Fairway Chevrolet and Fairway GMC/Buick
Site Development Review
3100 E. Sahara
Las Vegas, Nevada 89104

Landscape Enhancements, Building Elevation Modifications, and Screen Wall Relocation – Water District Equipment Access

Site Development Plan Review (SDR-38855) shall be amended to reflect minor changes to the Landscape Plan, Building Elevations, and Screen Wall at the northeast corner of the project site.

Re: Response to comments –CLV Project #40090-C-10

BODY SHOP SOUTH ELEVATION
1/8" = 1'-0"

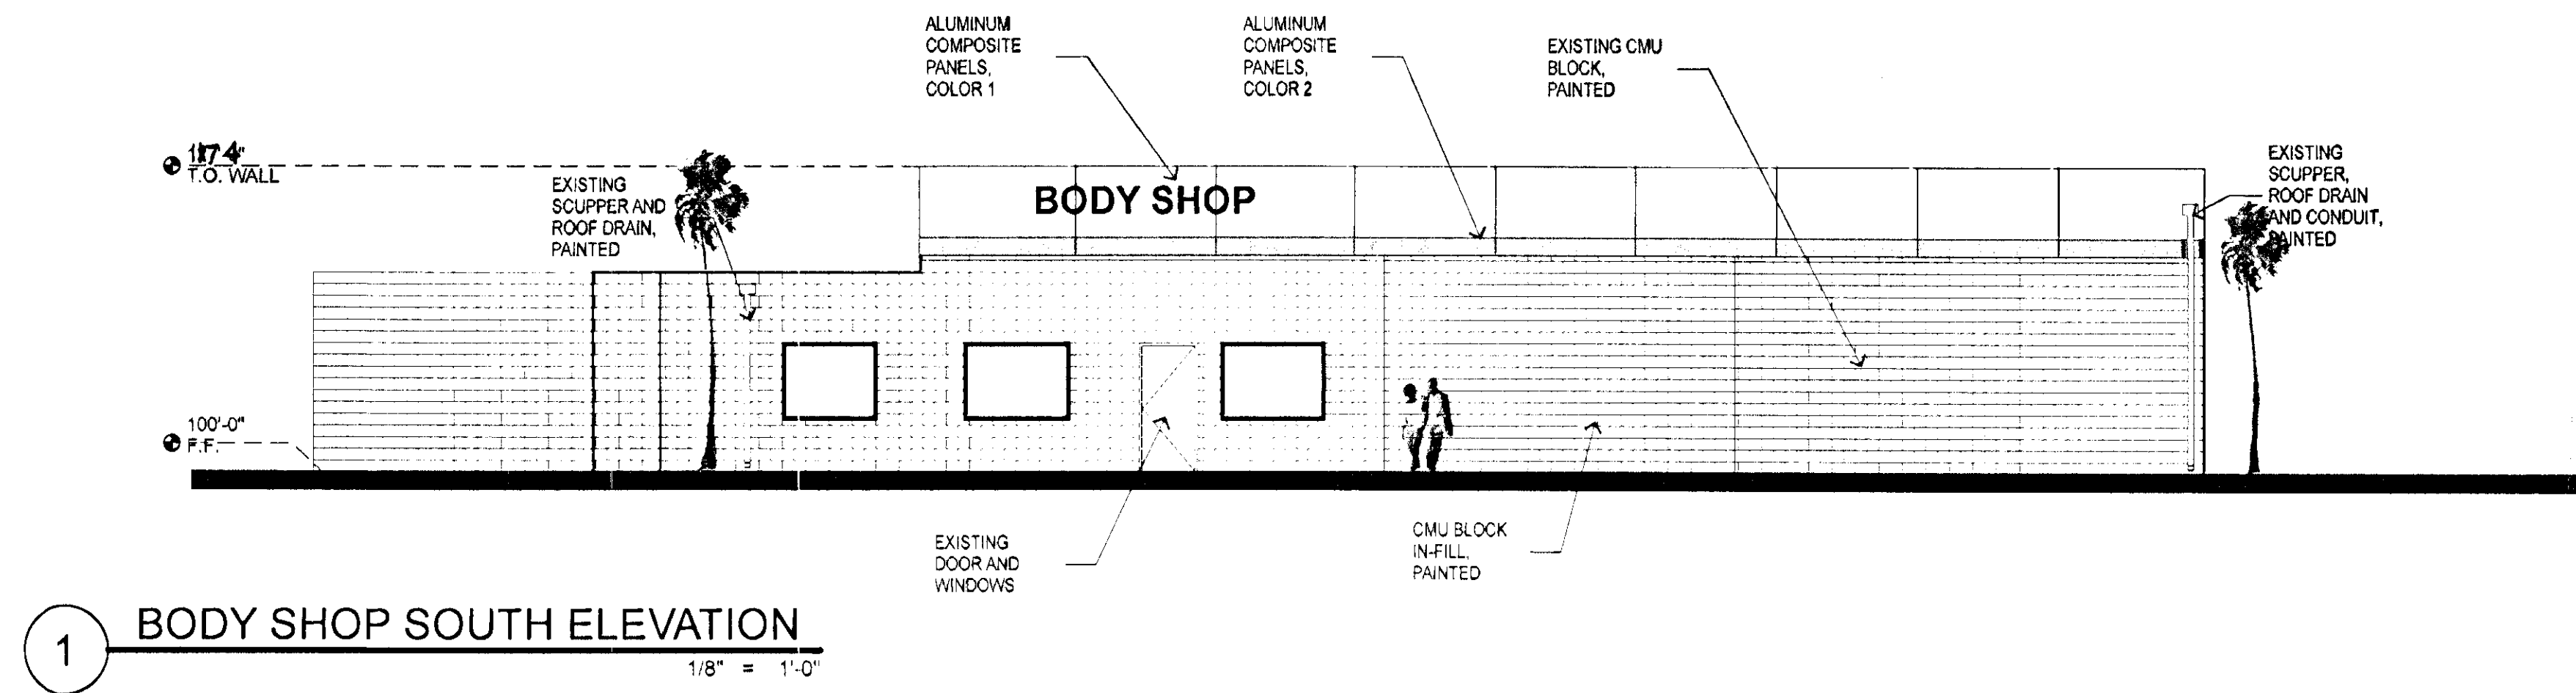
NOTE: WEST, EAST AND NORTH WALLS WILL BE PAINTED TO MATCH THE SOUTH WALL. NO OTHER CHANGES ON THE WEST, EAST OR NORTH WALLS WILL OCCUR.

SITE PLAN
AS100
10.069 Fairway Chevrolet and Fairway GMC Buick

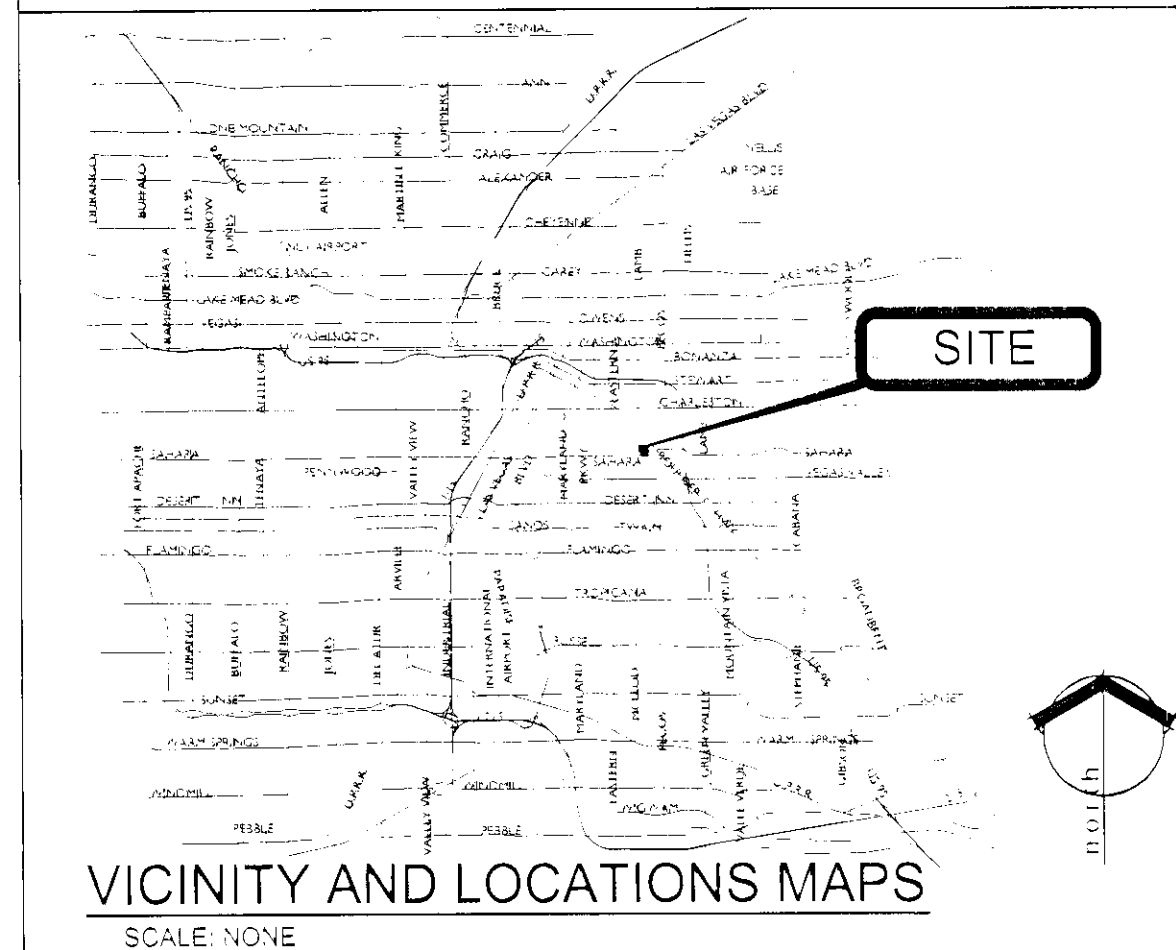
Item 2: Drawing AS100

The site plan has been revised to show the HC spaces.

Wheel stops have been added.

ENLARGED LANDSCAPE PLAN

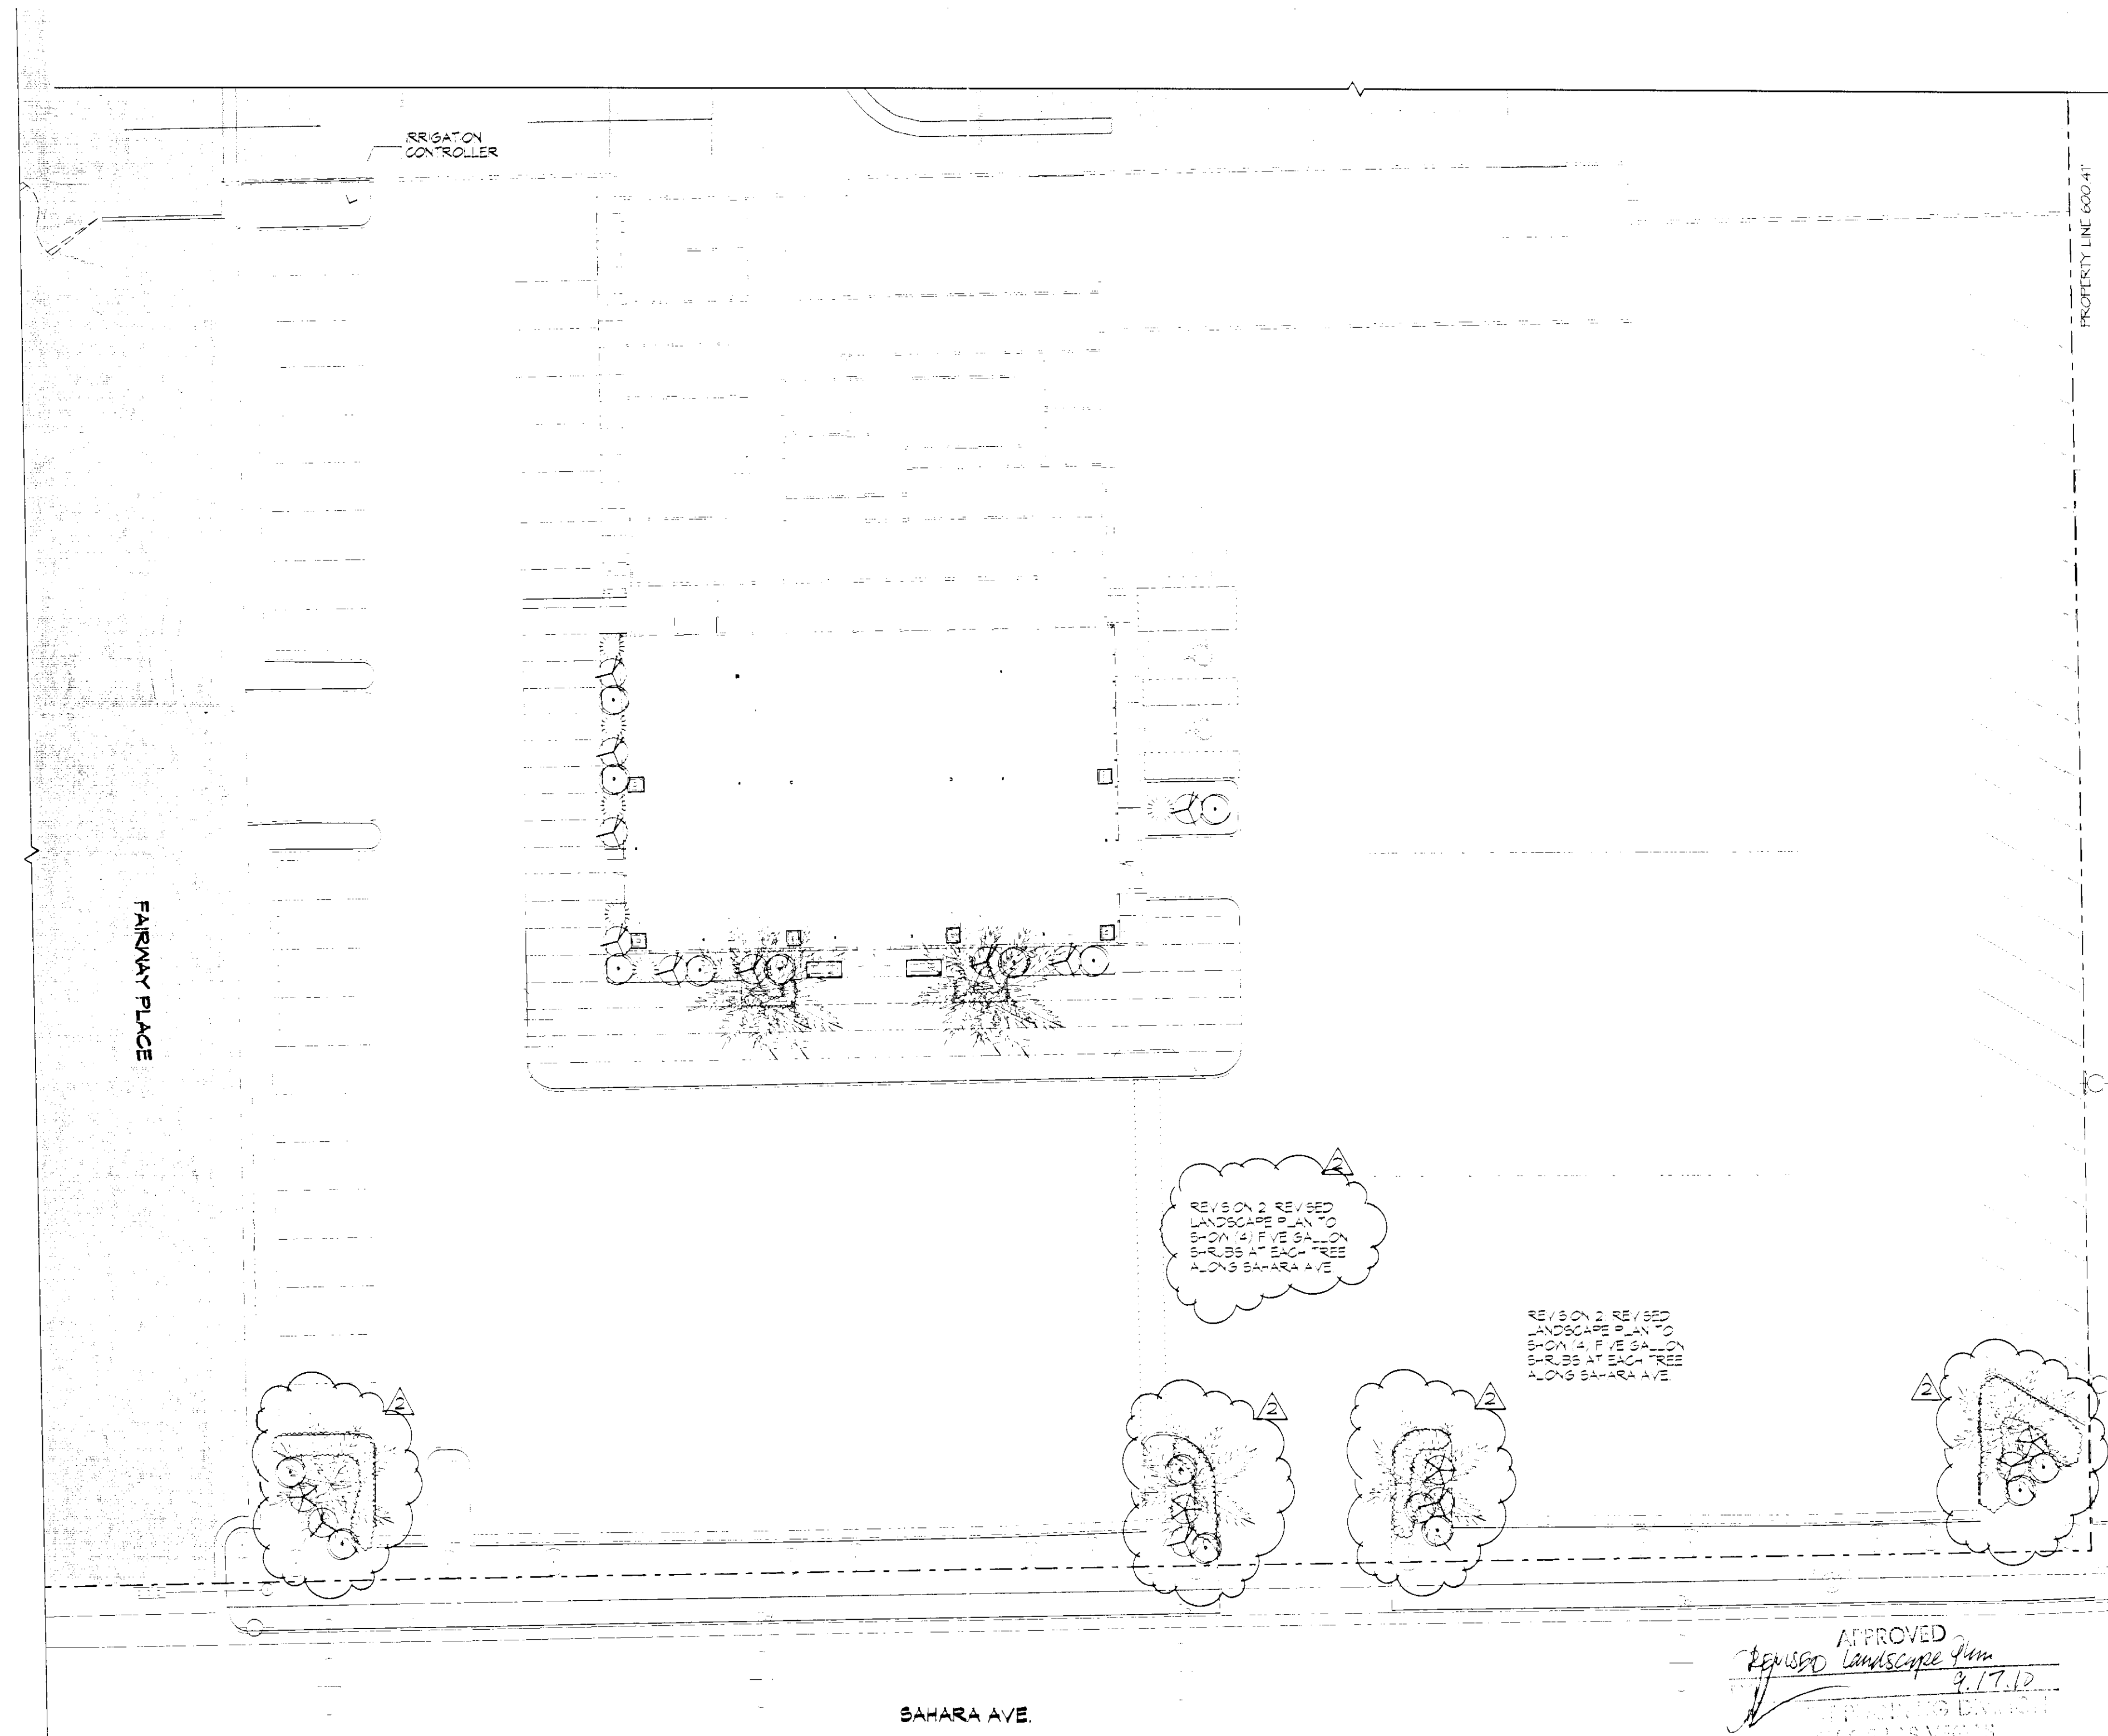
The Landscape Plan has been revised to add 3 Mexican Fan Palm Trees (16-18 feet tall) at the front of the property within a parking island and at the west and east front corner planters. The additional trees are considered an enhancement to the project site. The additional trees are considered an enhancement to the landscape plan and all other vegetation remains in conformance with SDR-38855.

DRAWING NO.
L100

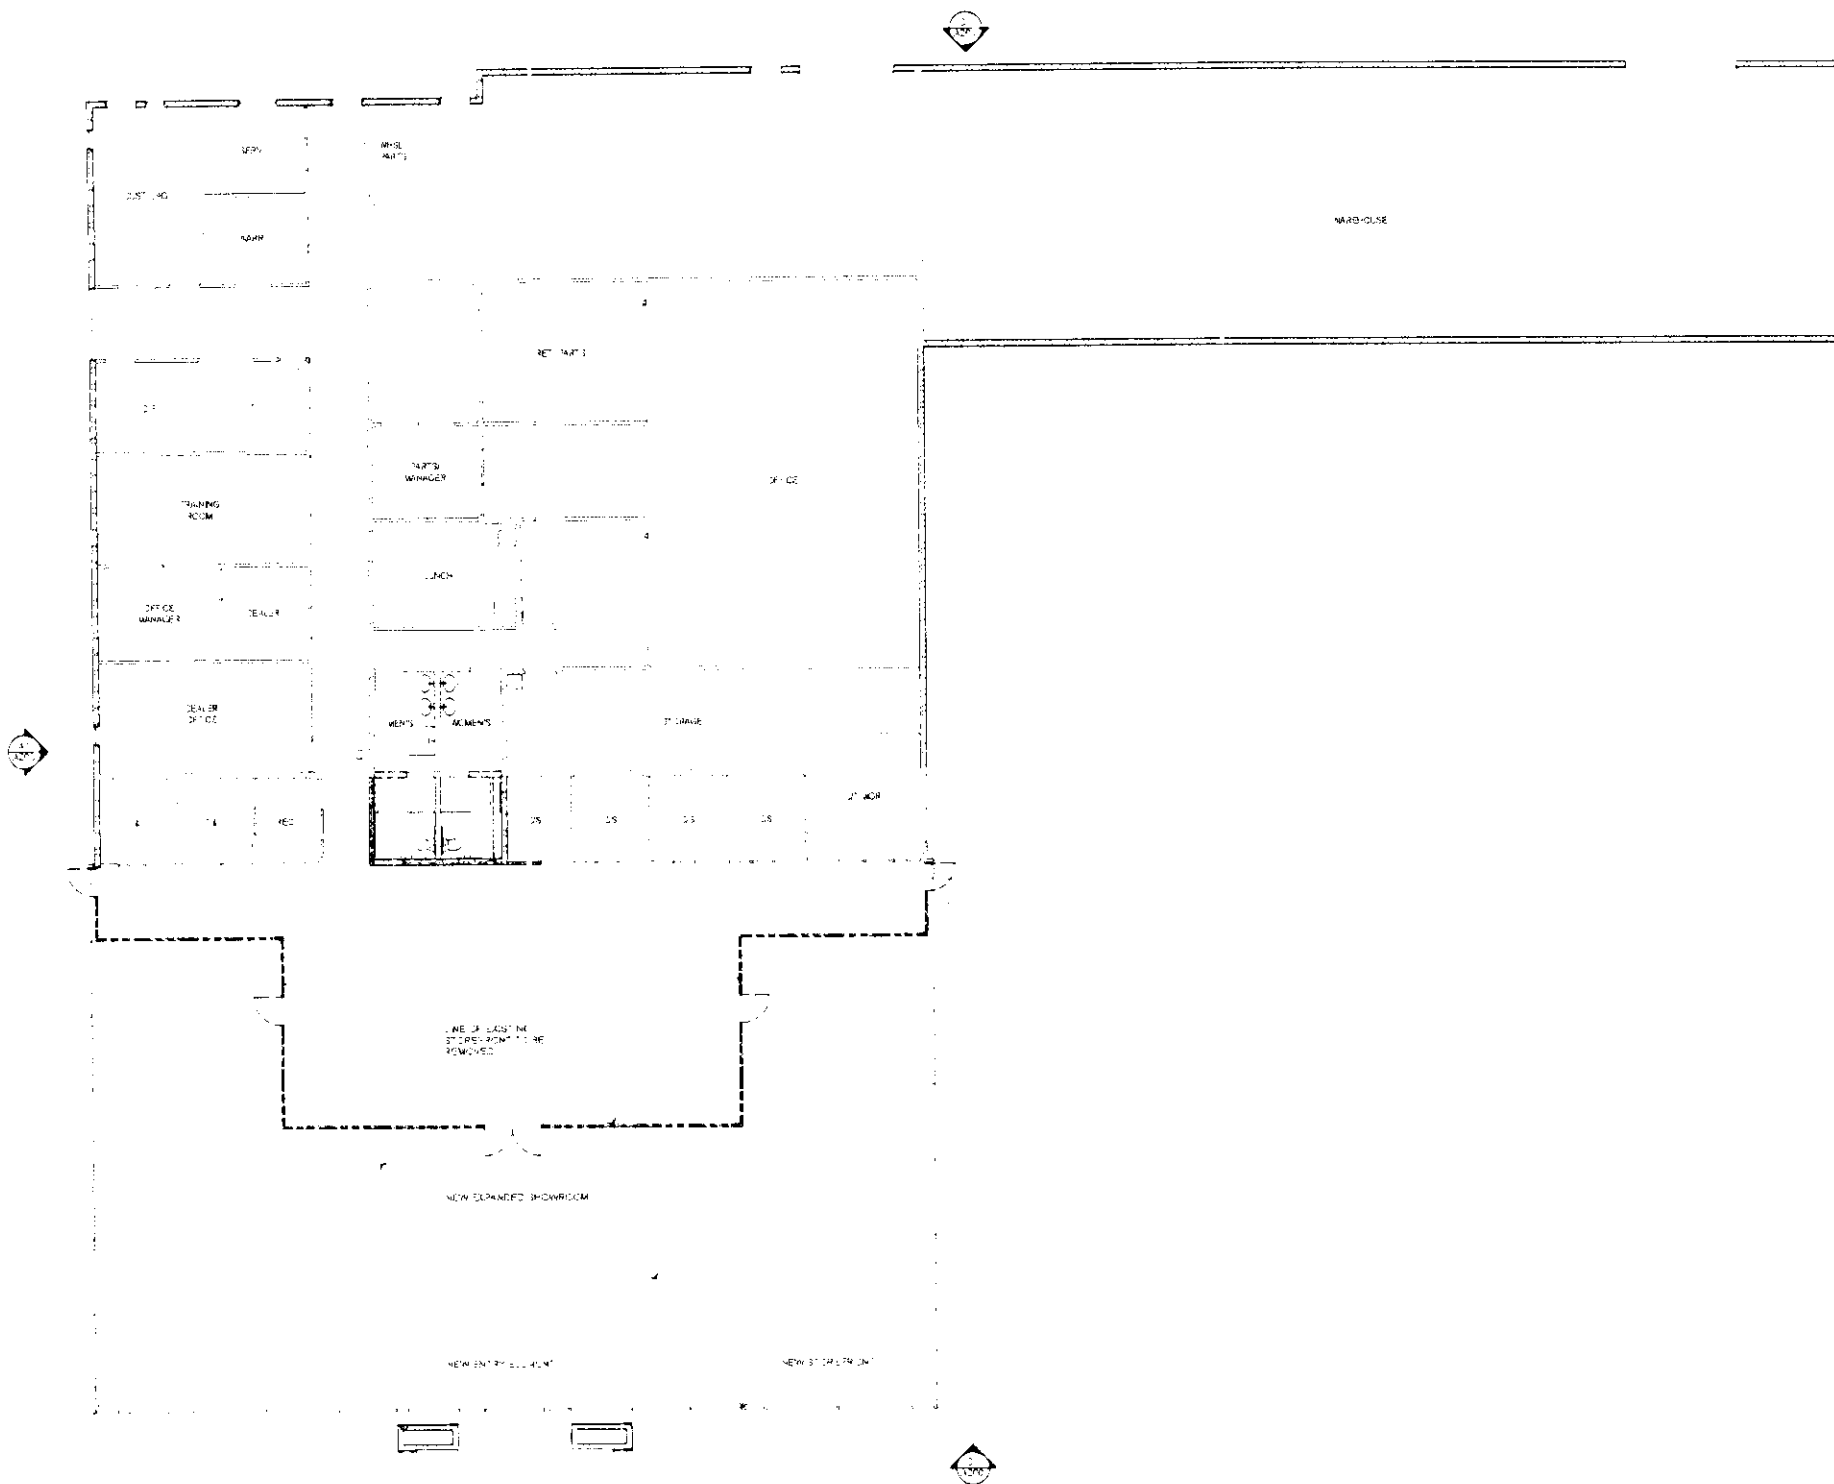
Minor revisions were made to the landscape plan to replace fifteen preexisting non-living 5 gallon shrubs along the south property line with fifteen new 10 gallon and 15 gallon shrubs (Yellow Bird of Paradise and Red Bird of Paradise). Additionally new 10, 5, and 3 gallon shrubs (Yellow Bird of Paradise, Red Bird of Paradise, and Lantana) will be installed on the west planter that runs parallel with Fairway Place. No effects to planter areas, parking or traffic circulation would result with from the revision. The modifications are considered an enhancement to the project landscaping and maintains conformance with Title 19.12 Landscape Standards.
